BURLINGTON DEVELOPMENT REVIEW BOARD Tuesday, February 17, 2015, 5:00 p.m. Conference Room 12, City Hall, 149 Church Street, Burlington, VT AGENDA

AMENDED PUBLIC HEARING NOTICE

From: Mary O'Neil, AICP, Senior Planner

SITE PLAN

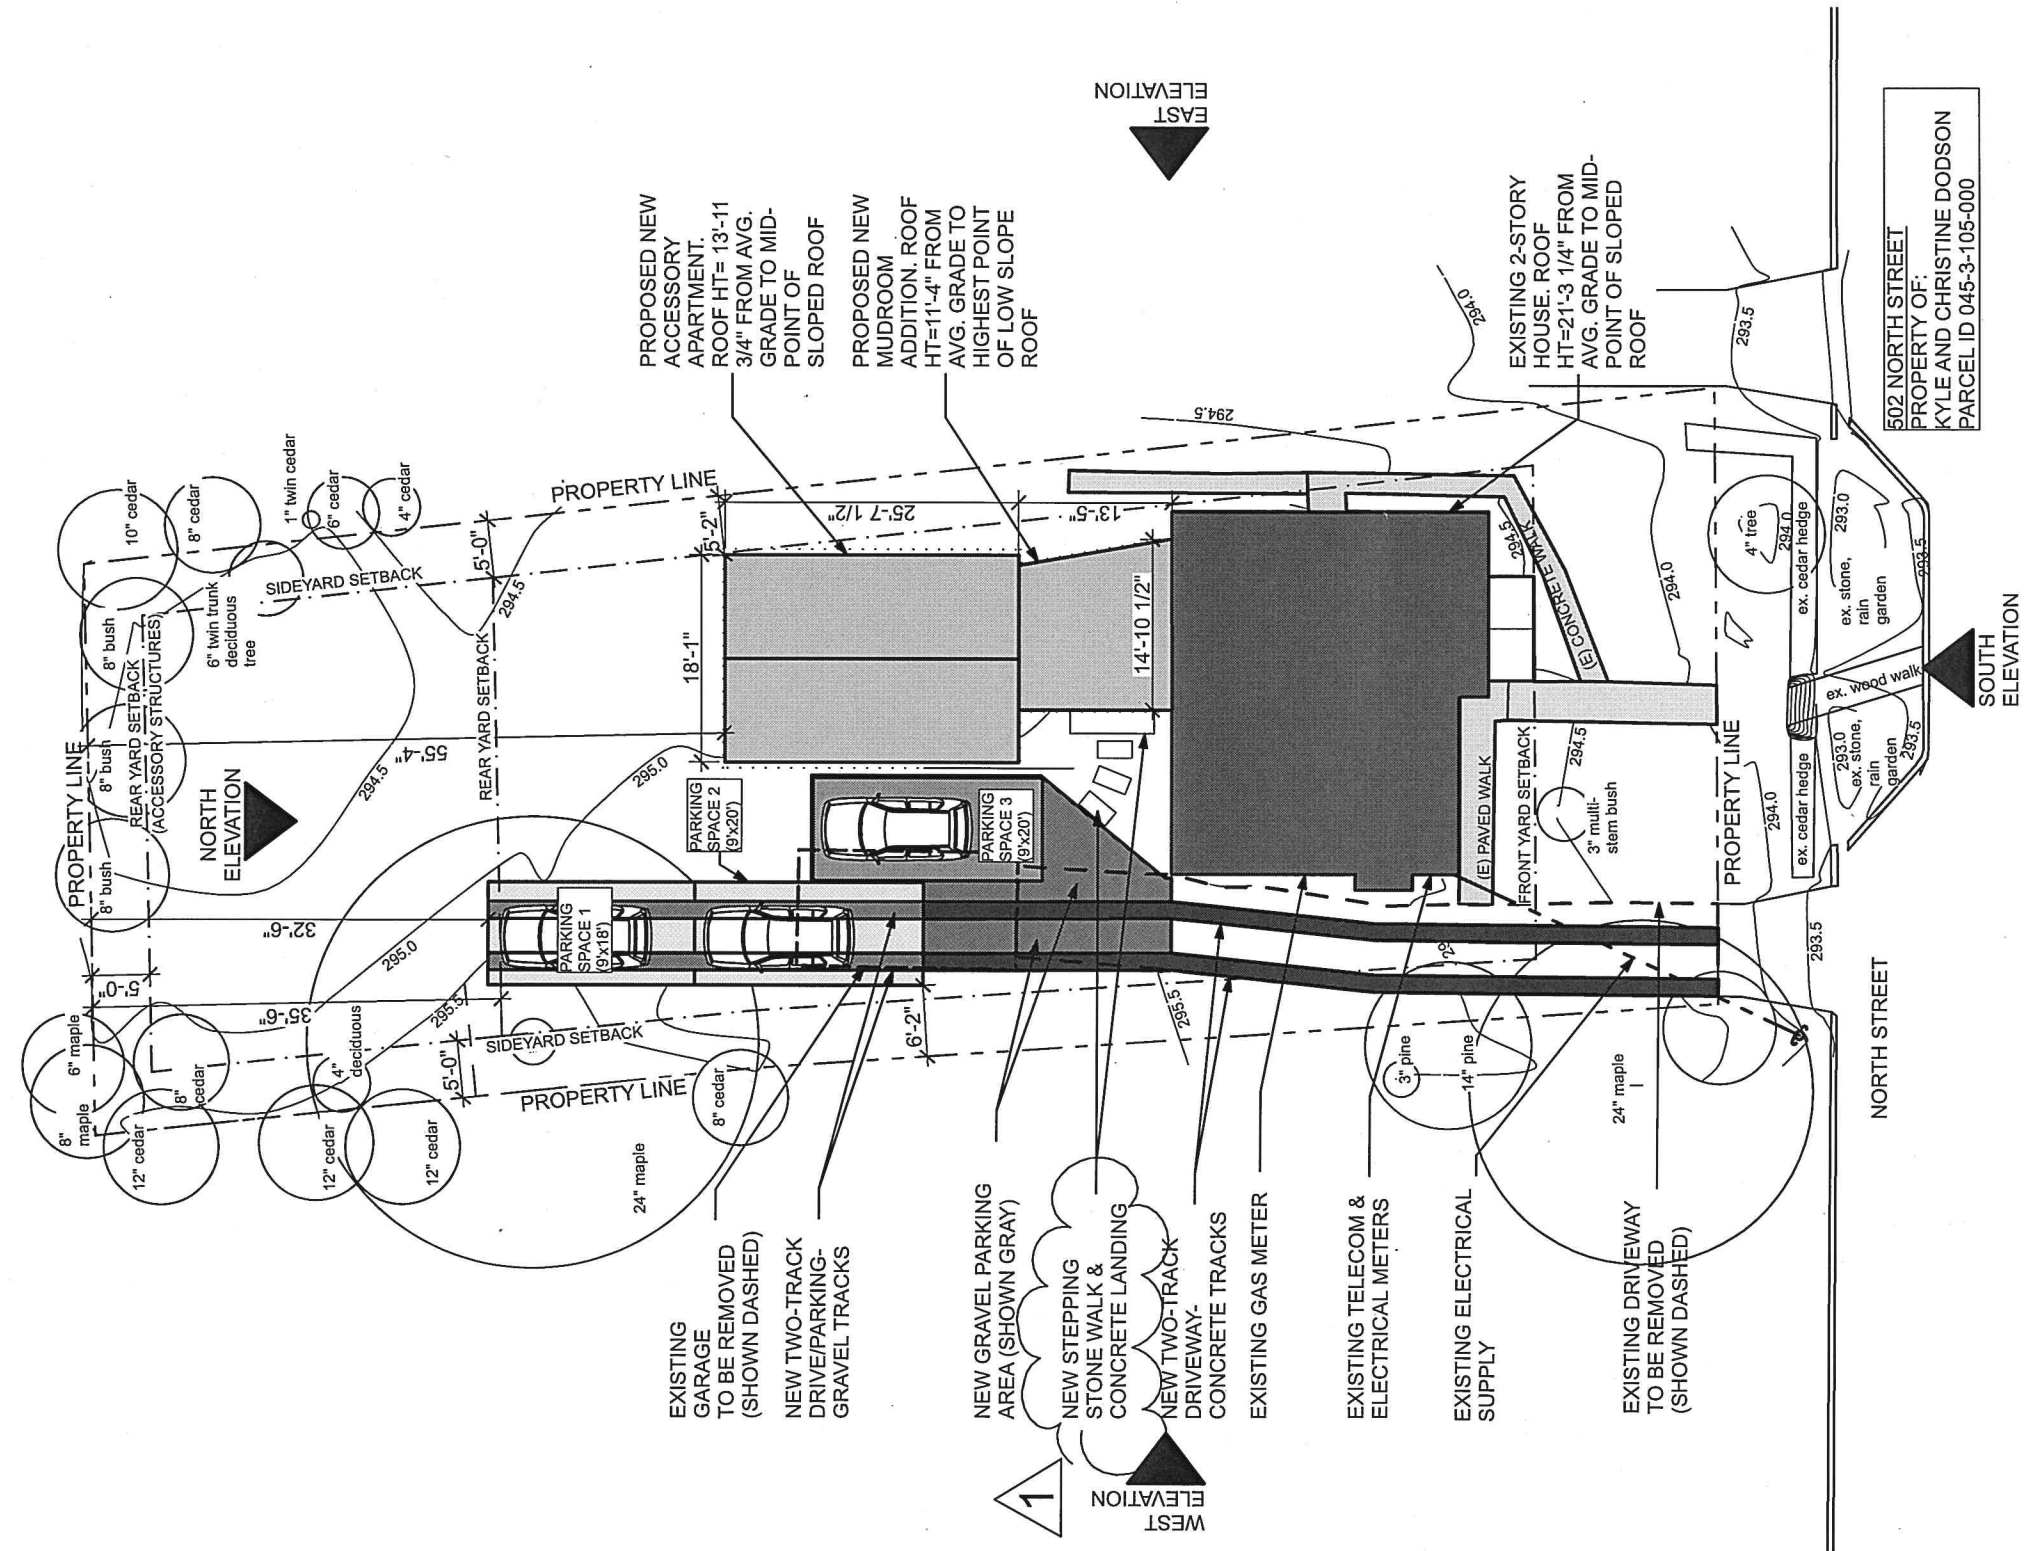
The revised site plans eliminate the previous discrepancy in lot coverage. The property is 7,277 sf and presently has 31.7% lot coverage. Within the RL zone, up to 35% lot coverage is permissible with an additional 10% allowable for things such as walkways, decks, and patios. With the construction of new lot coverage and removal of some existing lot coverage, proposed lot coverage will be 37.1%. This amount includes 32.7% standard lot coverage and 4.3% additional lot coverage allowed for walkways and stair landing area. This coverage is acceptable.

The width of the property varies between 52' and 48' wide. The minimum required side yard setback may be 10% of the lot width (or the average of neighboring properties). The site plan depicts a compliant side yard setback for the proposed construction of 5' 2" from the nearer side property line. The 136' deep property requires a 34' rear yard setback (25% of the depth). The site plan depicts a compliant 55' 4" rear yard setback. The reconstructed driveway adheres to existing or increased side yard setbacks and is acceptable. The front yard setback will remain unchanged.

Pedestrian access to the home remains unchanged. A walkway links the front door to the public sidewalk and will remain unchanged. The proposed apartment will share the mudroom entrance with the primary dwelling unit. As recommended by the Design Advisory Board, stepping stones will provide a walkway between the parking area and the mudroom door. **(Affirmative finding)**

1. **Prior to release of the zoning permit**, the exterior mail box vs. mudroom door mail slot shall be resolved, and edging material for the gravel parking shall be noted on the site plan. Revised plans shall be subject to staff review and approval.

TITLE:
PROPOSED SITE PLAN
SCALE: 1/32" = 1'-0"

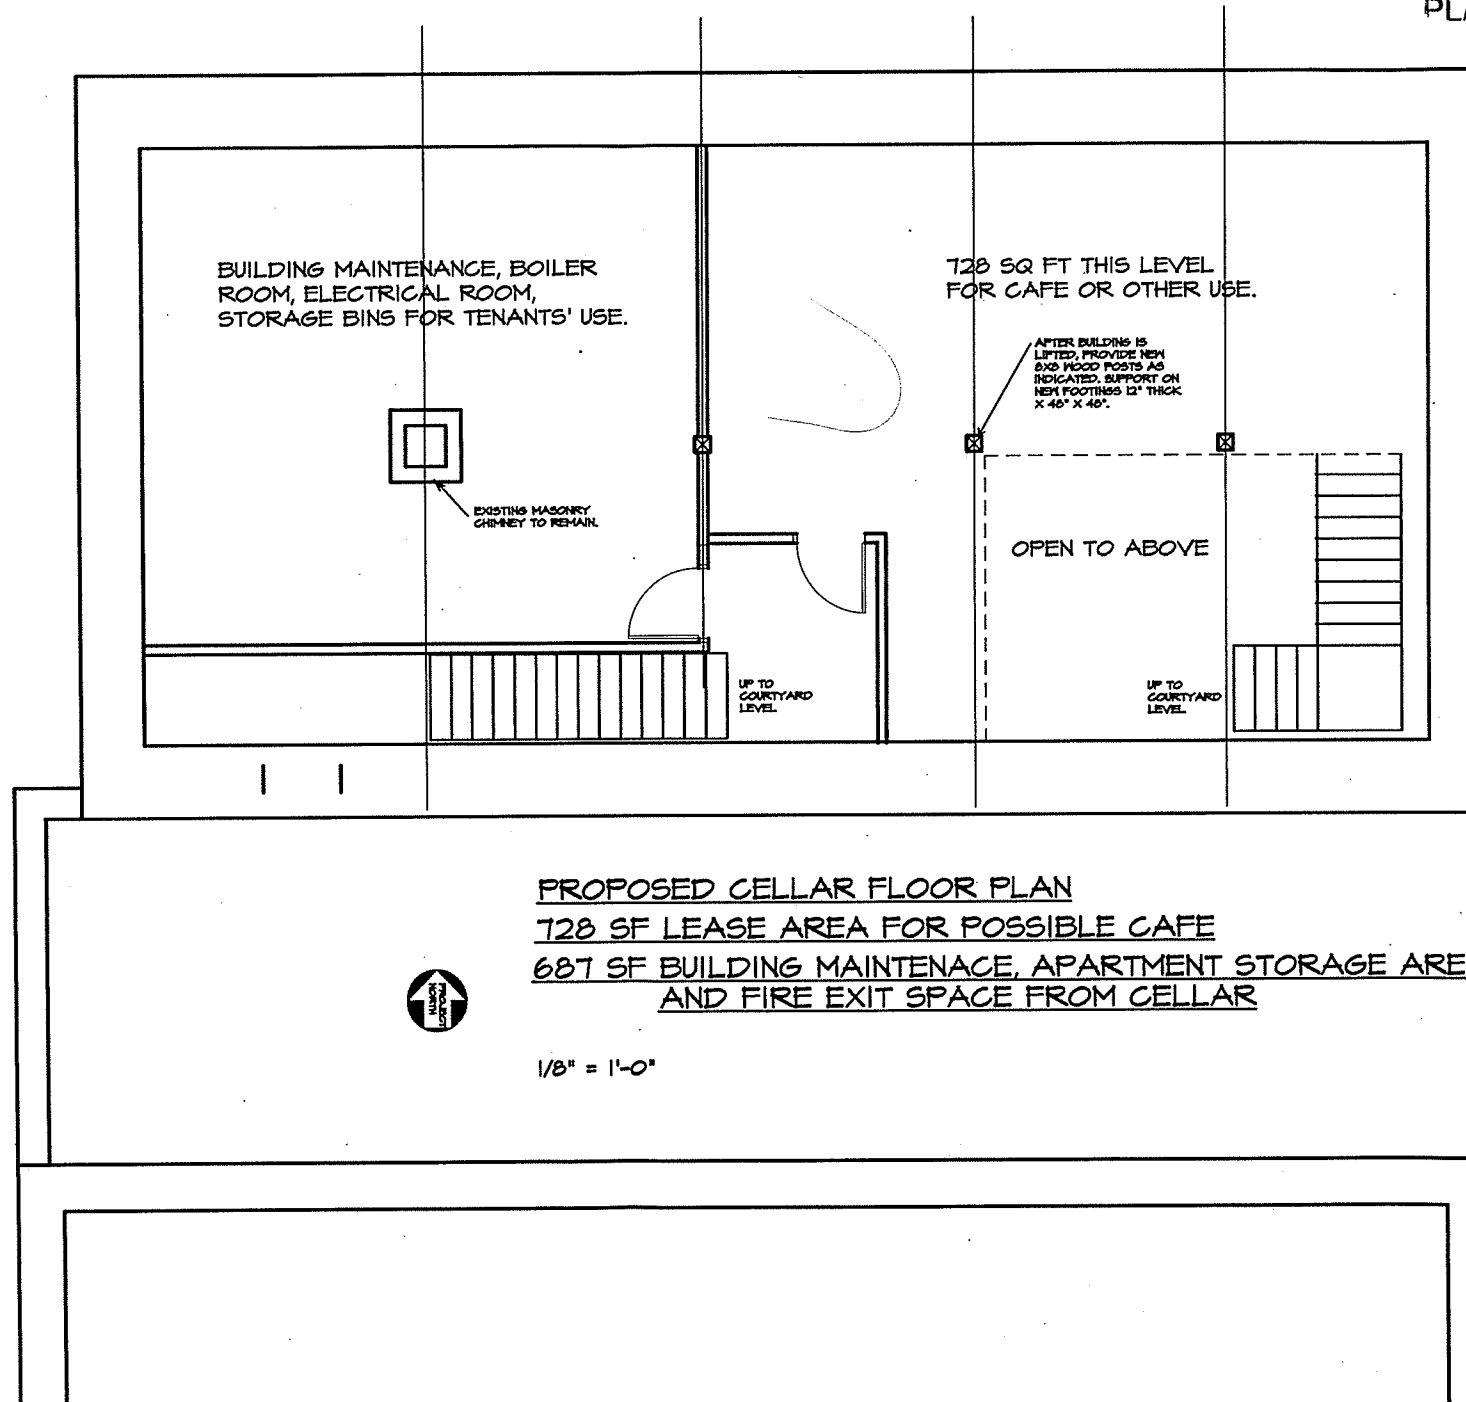
See Table 4.4.2-1, above. The suggested westerly porch and access ramp appear to be within the public ROW (from preliminary submission materials and previously approved site plans) and subject to approval by the Department of Public Works and agreement through the City Attorney's office, subject to City Council approval.

A revised site plan has moved the boundary line to the west, accommodating the replacement porch. A survey will likely be required to confirm the location of the boundary line and to ascertain where the public ROW begins.

Revised plans illustrate one on-site parking space, but no identified snow storage area if that spot is to be used. That parking location was identified in recent litigation as encumbered under easement to the abutting property to the east for parking turn-around. An accurate survey and an understanding of current use will be essential in determining if that parking space is factually usable.

Previous permitting has acknowledged only 1 on-site parking space (rear/south of the parcel. See 1987 site plan.) That parking space is now illustrated on a revised site plan. The applicant defines use of four *on-street* parking spaces; all within the public ROW. The applicant proposes the re-alignment of sidewalk, curbing and on-street parking as part of this project. All work within the public right-of-way is outside zoning jurisdictional review, and is at the discretion of the Department of Public Works and requires approval of the City Council.

TITLE:
EXISTING WEST ELEV.
PROPOSED WEST ELEV.
SCALE: 1/8" = 1'-0"

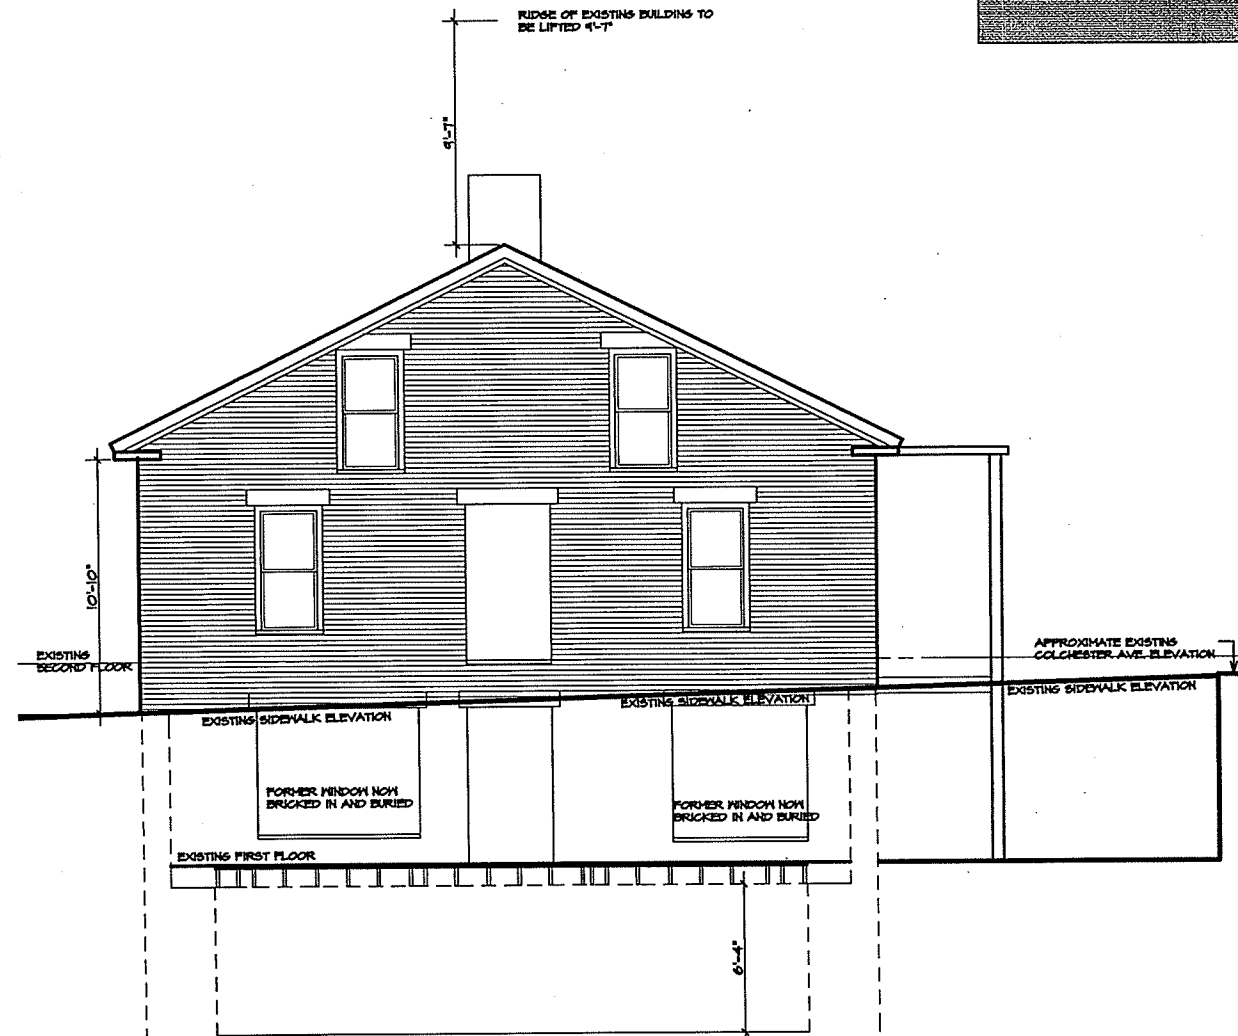
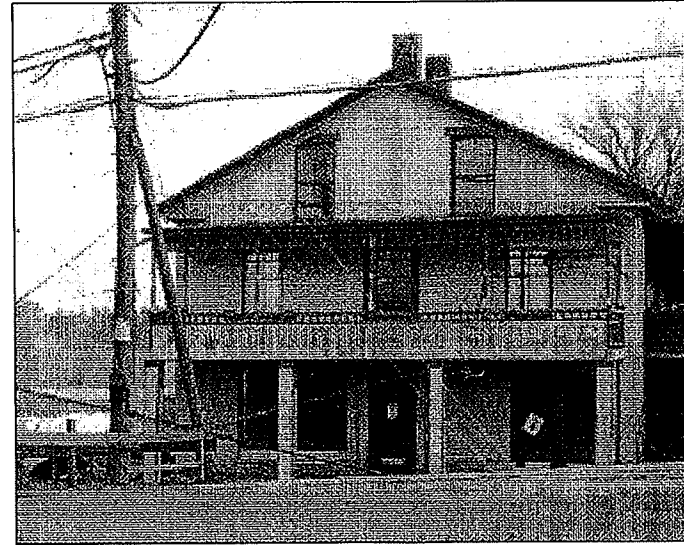
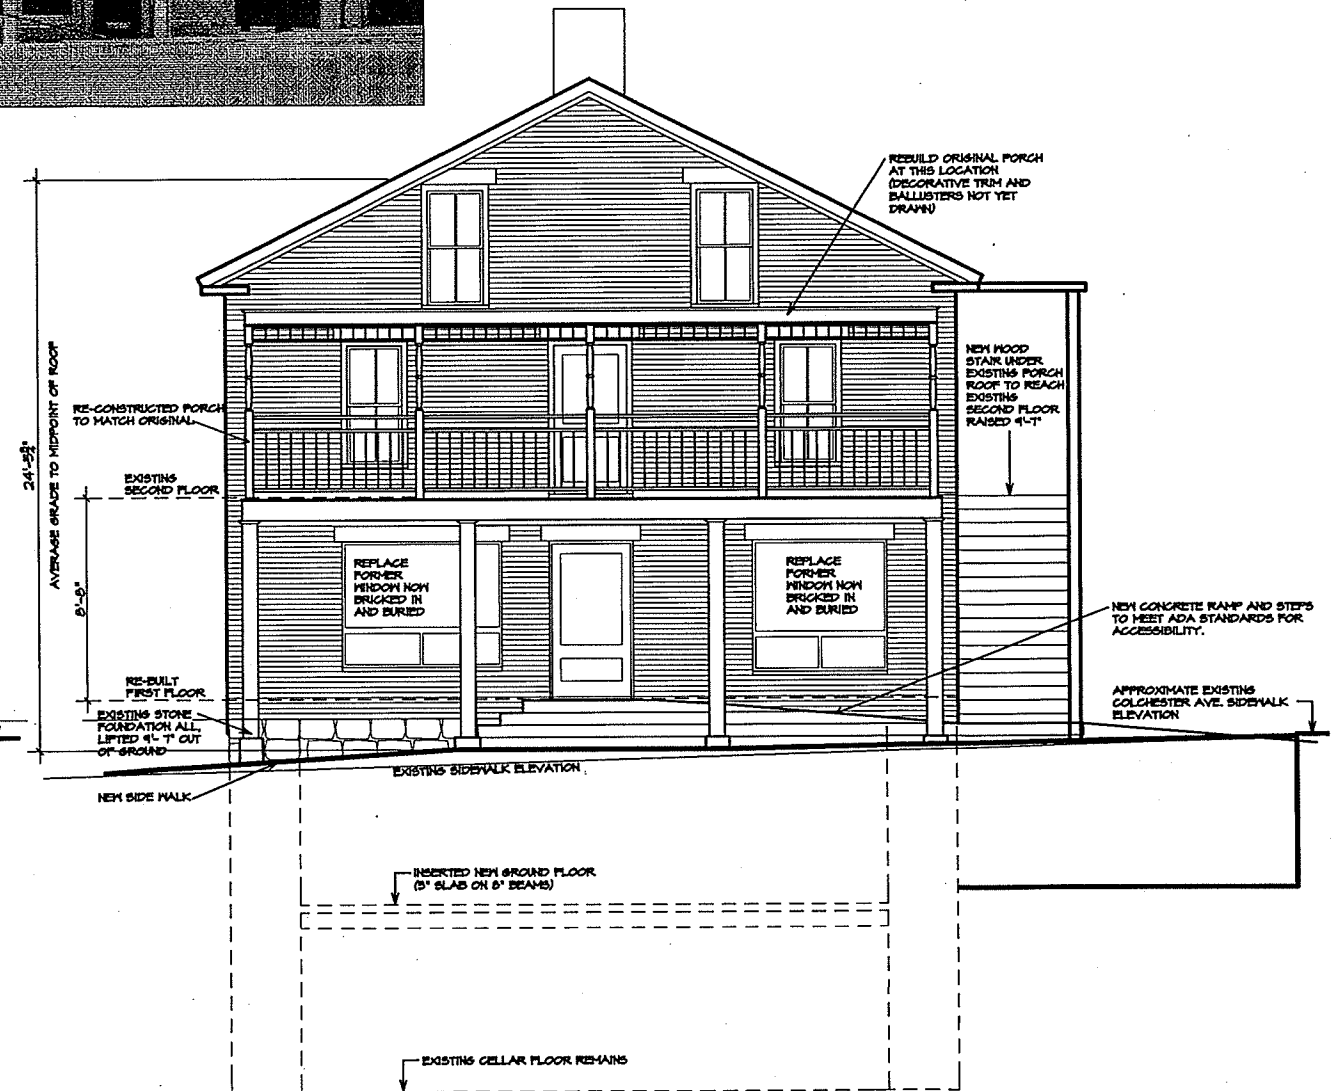
The proposed westerly replacement porch can be substantiated in historic photographs; however the plan illustrates the component further above grade than was historically evident. The additional wrinkle is the work potentially falls within the public right-of-way. As site plans differ on the location of the westerly property line, a survey will likely be required.

Grade changes are proposed to accommodate h/c access to a westerly door, and to ease the transition to the rear / south courtyard. Submitted plans should include contours to better understand how the topography is proposed for change.
